ARORA ESTATES

PRELIMINARY PLAN NO. 120230050, PRELIMINARY/FINAL FOREST CONSERVATION PLAN NO. 120230050

Application to create four lots for four single-family detached units.

No. 120230050

COMBINED PRELIMINARY & FINAL
FOREST CONSERVATION PLAN
ARORA ESTATES
10400 BOSWELL LANE & 12900 GLEN MILL ROAD
POTOMAC, MD

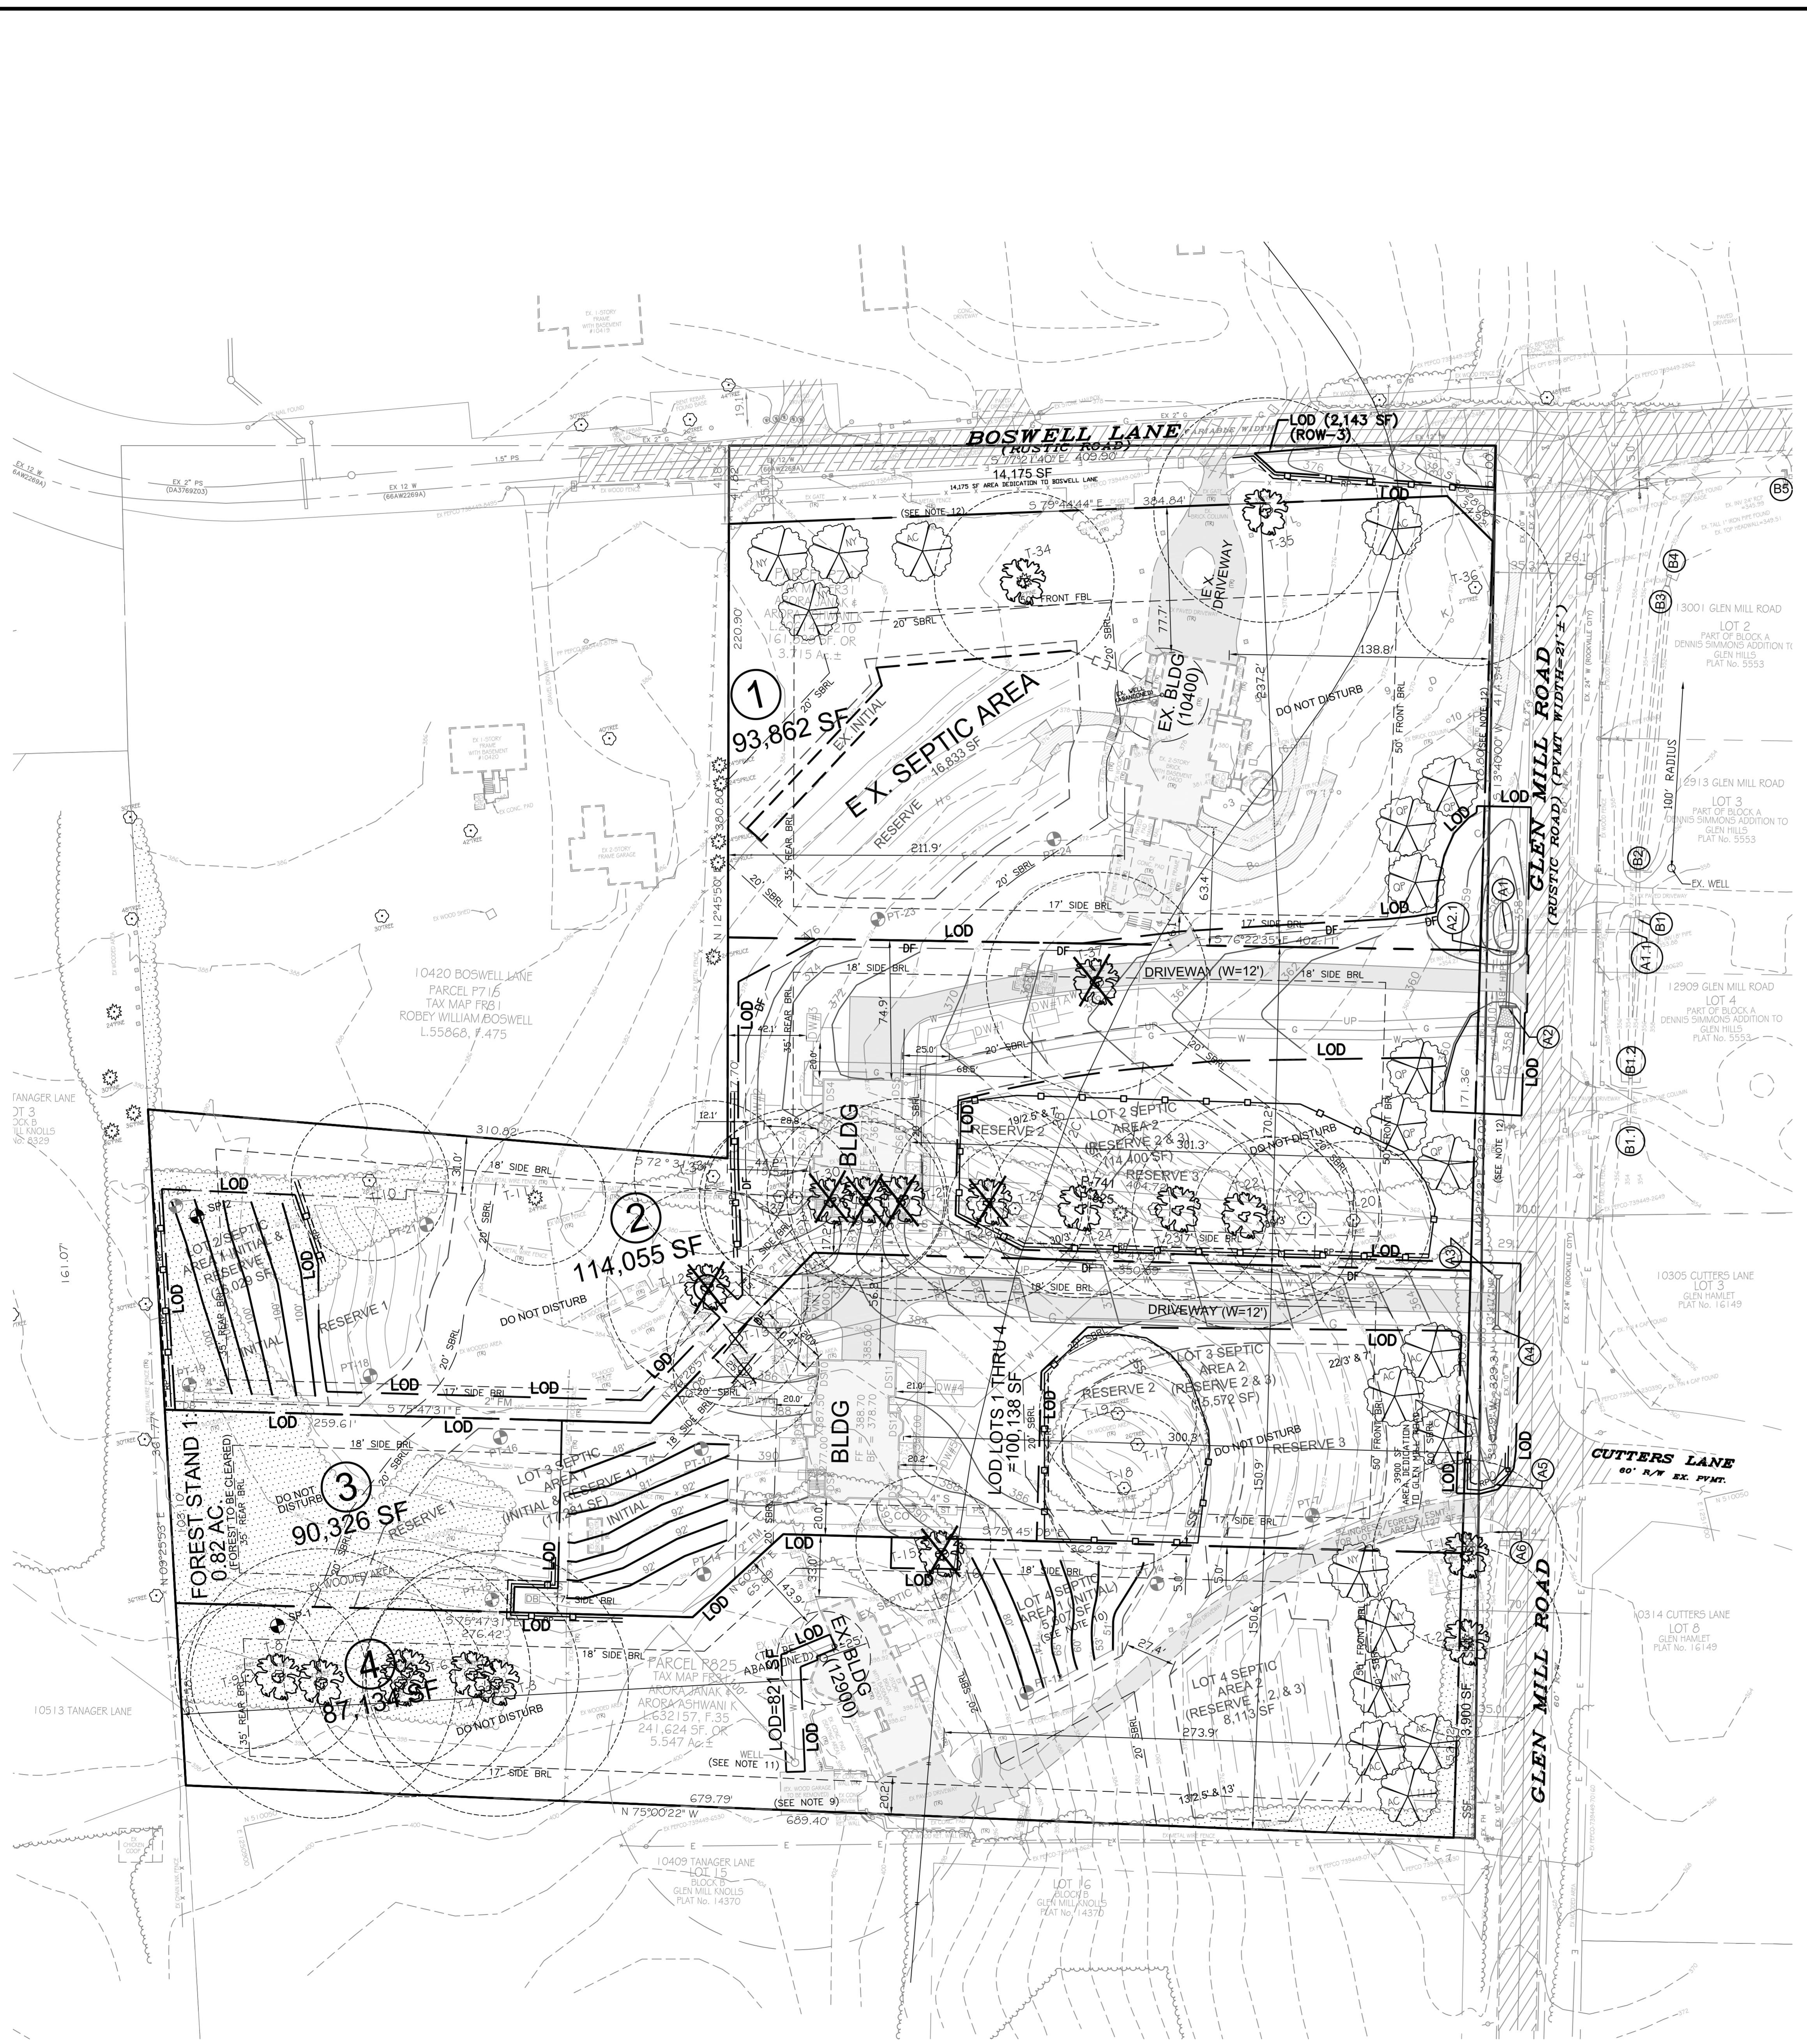
The Applicant submitted a variance request in a letter dated April 16, 2023 (Attachment D). The Applicant proposes to impact eight and remove seven trees that are 30 inches or greater DBH, that are considered high priority for retention under Section 22A-12(b)(3) of the County Forest Conservation Law (Table 4).

Per Section 22A-21, a variance may only be considered if the Planning Board finds that leaving the requested trees in an undisturbed state would result in unwarranted hardship, denying the Applicant reasonable and significant use of their property. A reasonable and significant use of the Property is the expectation to subdivide and subsequently develop the Property in accordance with applicable development standards of the RE-2 zone. This includes the two-acre minimum lot size standard. In this case, the unwarranted hardship is caused by the combination of the necessary layout of the proposed development on the Property which is dictated by the existing site conditions, development standards of the zone and Montgomery County agency requirements combined with the location of the Protected Trees. There are eight Protected Trees requested to be impacted and seven Protected Trees requested to be removed all of which are located within or adjacent to the limits-of-disturbance ("LOD") within the developable area of the Property (Figure 5). These trees are, for the most part, centrally located within the Property. Therefore, virtually any permitted use, constructed in accordance with the RE-2 development standards, would be expected to impact at least 10 of the 15 Protected Trees.

The inability to impact or remove these highly impacted Protected Trees would potentially render portions of the site undevelopable for this Project or pose threats to the health, safety and welfare of future homeowners, and deny the owner of a reasonable and significant use of the Property. Therefore, there is a sufficient unwarranted hardship to justify a variance request because the Applicant would otherwise be denied the ability to use the Property for the proposed subdivision and subsequent development of single-family detached homes allowed under the zone, which is a reasonable and significant use of the Property.
